A-6378 Variance Requests (a & b)

CHEVY CHASE VILLAGE
BOARD OF MANAGERS
JULY 8, 2013 MEETING

STAFF INFORMATION REPORT

SUBJECT: HEARING OF APPEAL CASE NO. A-6378 (A&B) VARIANCE REQUESTS
MS. SYDNEY BRAY & MR. WILLIAM JOHN BRAY III, 104 OXFORD STREET
TO CONSTRUCT A SECOND FLOOR ADDITION ABOVE AN EXISTING SINGLE STORY:
A) THE SOFFIT AND GUTTER OF WHICH WOULD ENCROACH A MAXIMUM OF ONE FOOT, FOUR AND THREE-QUARTER INCHES (1'-4 ¾") INTO THE SEVEN (7) FOOT EAST (SIDE) YARD SETBACK; AND
B) THAT WOULD ENCROACH A MAXIMUM OF FOUR FEET, FIVE AND ONE-QUARTER INCHES (4'-5 ¼") FORWARD OF THE TWENTY-FIVE (25) FOOT FRONT (SUMMERFIELD ROAD) BUILDING RESTRICTION LINE.

2 WEST ELEVATION - EXISTING

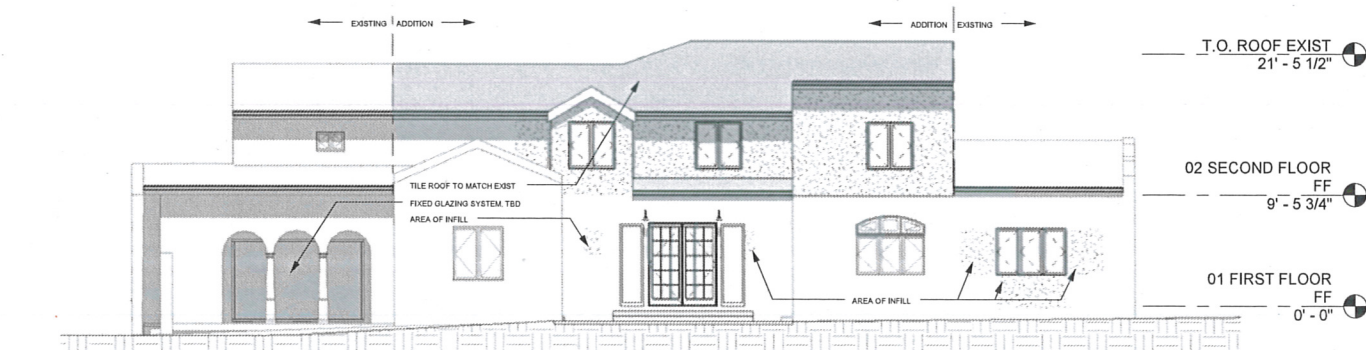
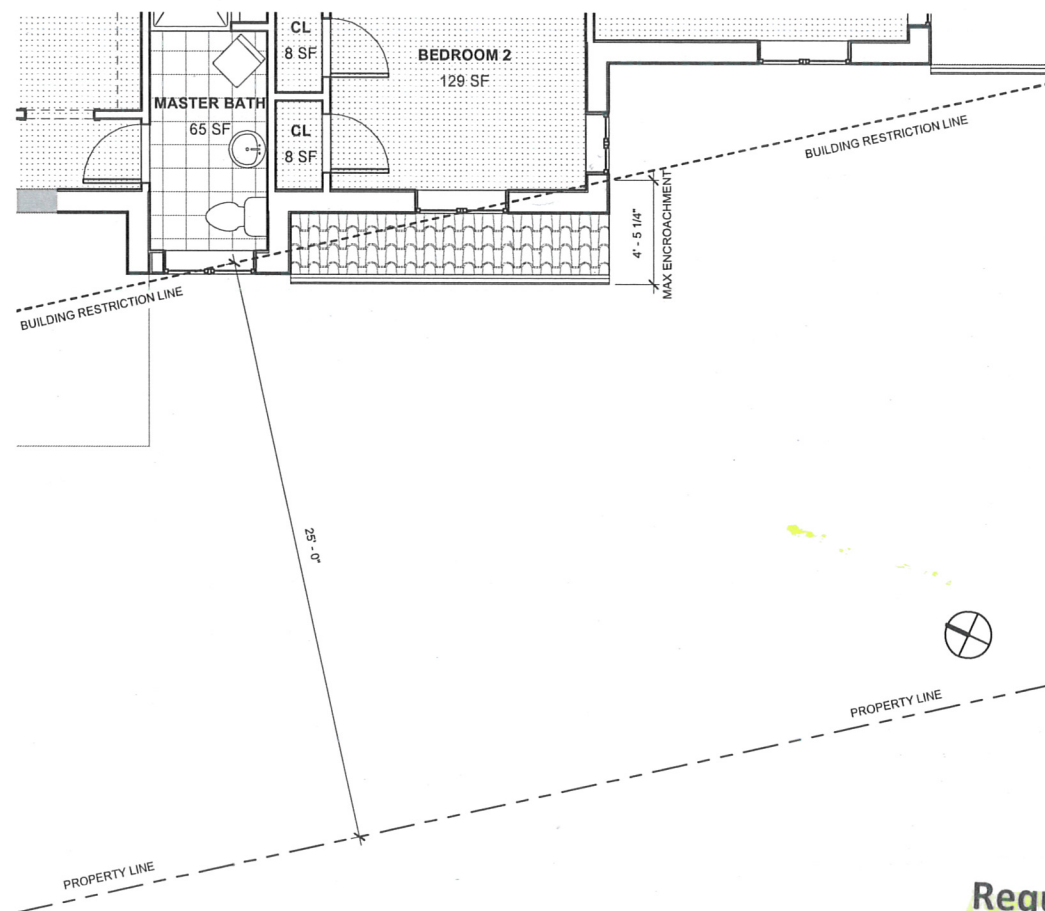
In the east (side) yard, a portion of the existing one story house encroaches a maximum of two feet, ten inches (2'-10") into the setback, however this portion will not have a new second floor above it.

The soffit and gutter of the proposed second floor would encroach one foot, four and three-quarters inches (1'4 ¾") into the east (side) yard setback.

Request A

1 2nd FLOOR - SETBACK

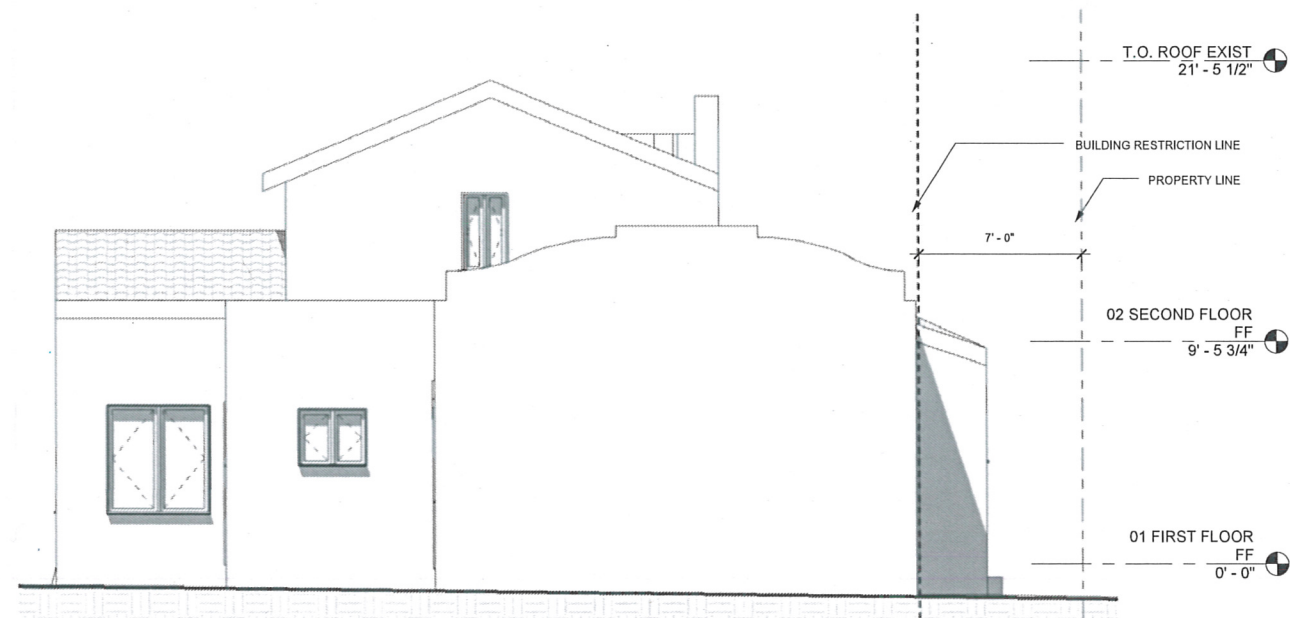
The requested variance along the east side of the Subject Property for the proposed roof overhang will exacerbate the dark shadows and obstructed views caused by the second story addition into these now pleasant rooms. Our living room is the center of our home with soft light year round. That wonderful living space will be darkened year round by the alterations. Most importantly, the windows in the neighbor's proposed master bedroom, grand staircase and bathroom less than 17 feet away from our home will view directly into our master bedroom and living room at all times. Reviewing the design of the proposed addition makes us appreciate the care that the original architects of 104 and 106 Oxford took to ensure privacy and compatible living between these two closely located residences.

5 SOUTH ELEVATION - EXISTING

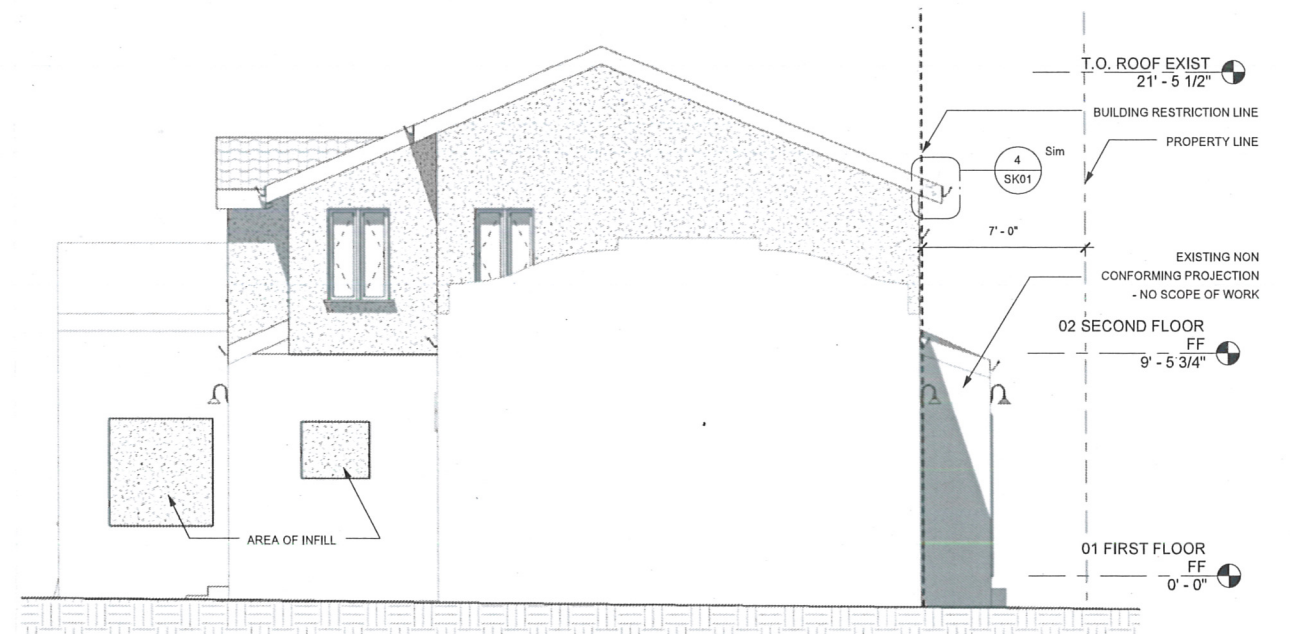
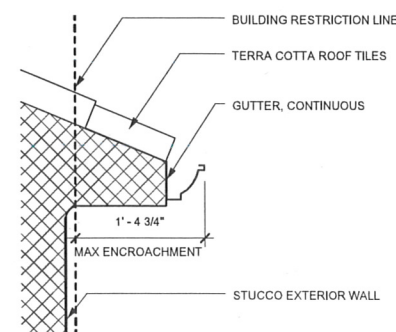
In the front (Summerfield Road) yard, the existing house encroaches a maximum of approximately six feet, ten inches (6'-10") forward of the front building restriction and covenant setback line.

Request B
